Dear Editor, dear Referees,

Point-by-point response to referee comments, our answers are in red.

Fig. 2 in submitted manuscript, main text:

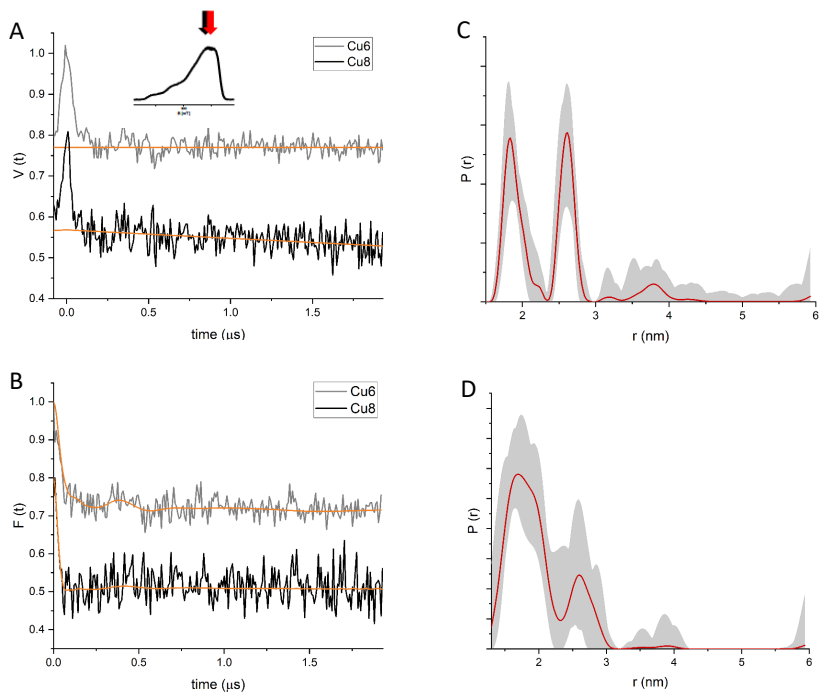
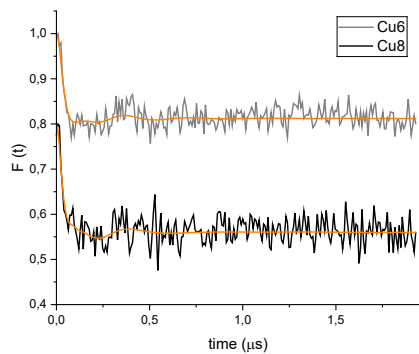
Figure SI.4 The raw data (A) shows no noise but very strong ESEEM-like modulation on top of some typical DEER form-factor. The background corrected data (B) has much stronger noise that masks the high frequency modulation (if it is still there). This data is clearly not just background subtracted (and cut). The noise seems also to increase upon background correction in Figure 2 (main text). Are these the forma factors after validation with added noise?

A central part of the discussion focuses on the modulation depth. Unfortunately, the signal-to-noise ratio (SNR) of the DEER data is low. For example, in Figure 2B, the normalization appears unreliable given the noise level. While these experiments are undoubtedly challenging—particularly in light of the short phase memory times (T_m) reported in the Supporting Information—the current data quality does not allow robust conclusions to be drawn.

Response: We are grateful to the reviewer for alerting us to this. Indeed, the traces shown in the figures (Fig. 2 of the main text and Fig. SI 4) show the traces with added noise, because they were taken from the analysis after validation. In the attached Figures, we show the proper data that should have been in the figures.

Response: See comments at the beginning of this document, the Figures shown below and our response to the last minor point of referee 2. In short: The data after background subtraction are fraught by the extra noise added in the validation process, and therefore carry extra noise (Fig. 2 of the main text and Fig. SI 4). In the attached Figures, p.14 and 15, we show the proper data that should have been in the figures.

Proper panel for Fig. 2B:
